PRELODGE MENT PANEL ADVICE

EIS CONSULTATION AND ADVICE

PROPERTY:	1-5 Khartoum Road, Macquarie Park																		
MEETING DATE:	5/12/2024	TIME:	9.30am to 10:30am																
PRELODGE MENT No:	PRL NO 2024/0027																		
DEVELOPMENT:	Demolition of the existing structures and Construction and operation of a data centre that includes, part road construction, landscaping, carparking and associated infrastructure. The Application is proposed under State Significant Development Application																		
ATTENDANCE:	Council:

Figure 3: Ground floor Plan (Source: Greenbox Architecture)

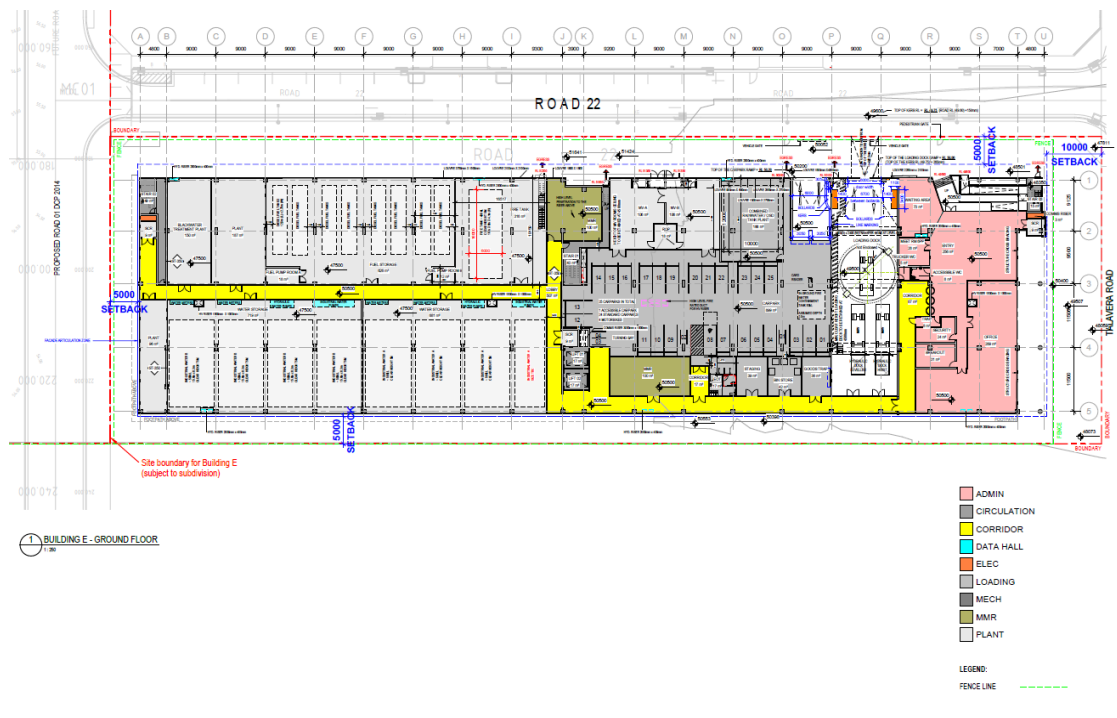
- The system must be located at the lowest point of the site, close to the discharge point, so as to ensure that the entire development could readily be routed through it. It is noted that the architectural plans have located a potential onsite detention / rainwater tank storage midway up the lot, which is less than ideal.

A review of the plans however notes that, at most, there would appear to be some 1700m² of commercial area, warranting only 17 spaces. Accordingly, the proposal appears to have an excess number of parking spaces which would not be compliant with the transport objectives of the Macquarie Park corridor. The issue is exacerbated further that the area is ancillary to the primary use of the site and unlikely to be fully utilised. Notably some 1021m² of the area is labelled as CLIENT STORAGE / STORAGE on the plans.

- Both vehicle entry points have a gate adjoining the road boundary alignment and therefore will result in vehicles having to stand on a public road waiting to enter the site. Any traffic control mechanism must be positioned such to accommodate the largest vehicle wholly off the public domain.

- The vehicle entry width into the loading bay / service vehicle area should coincide with AS2890.2 requirements and permit a minimum 6.5m opening (as per internal driveway width).

Figure 5: extract showing Council stormwater assets (Source: Ryde Maps)

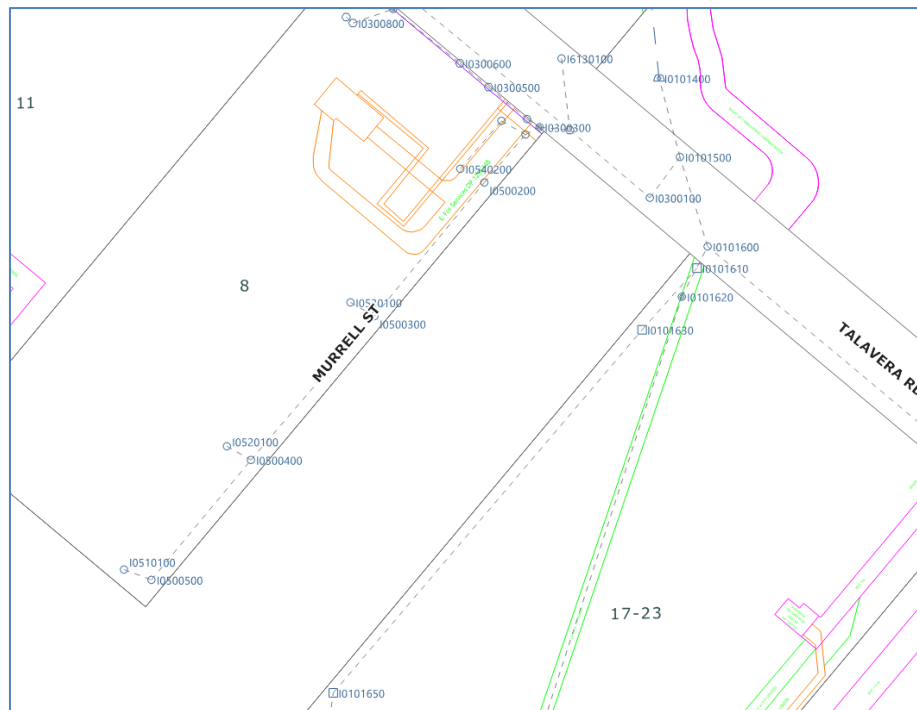
Please ensure the Council pit, which is being connected to, is indicated on the plans with Council pit numbering. Please see figure 5 below drainage diagram for your reference:

Figure 7: Section of Draft Architectural Plan (Source: Greenbox Architecture)

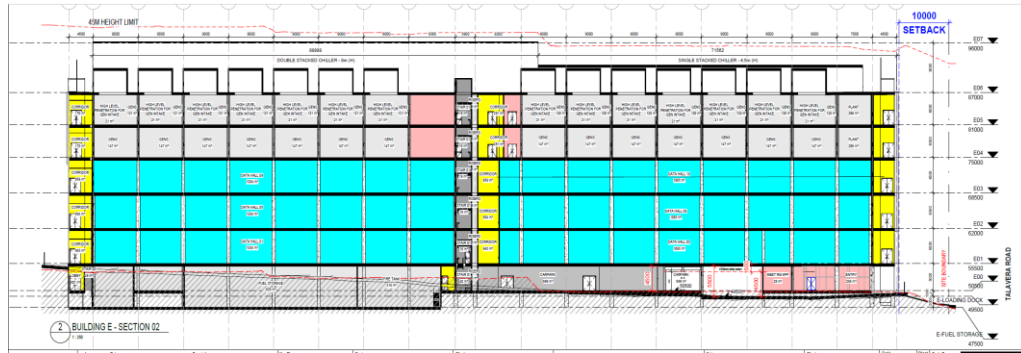
- It is understood that the fire tanks and fuel storages are proposed below the NGL on a basement level. To ensure the proposed tanks remain operational and safe during extreme flood events, please ensure that the openings, vents, access points are proposed above the PMF flood. The plans submitted with the EIS should demonstrate this.

- The finished floor levels are to be clearly shown on the plan and shall match the ones instructed in the final Flood Report.
- A cross section of the basement ramp to be provided and clearly demonstrate that the crest of the basement ramp is designed up to PMF level.
- Openings above fuel tanks are above the PMF level.

Figure 10: Extract from Ground floor Plan (Source: Greenbox Architecture)

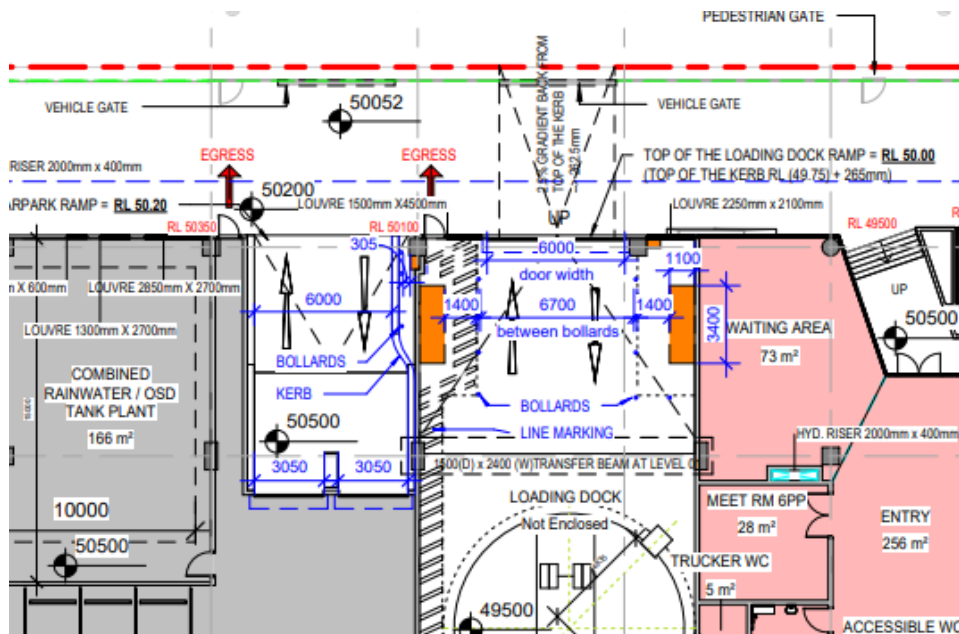
Vehicular access to the site is from Road 22 and consists of a car park entrance and a separate loading dock entrance. The loading dock entrance is at a 90-degree angle to the Road 22 kerb

line and Council has concerns that the proposed arrangement will not adequately facilitate movements for larger vehicles. It may be necessary to provide an angled vehicular entrance to facilitate access requirements of larger vehicles without impacting other road users or interrupting traffic flow. Swept paths for the largest vehicle type accessing the site should be provided to confirm that the proposed vehicular access arrangements are adequate.

- Provide swept paths demonstrating adequate access arrangements for the largest vehicles required to access the site from Road 22.
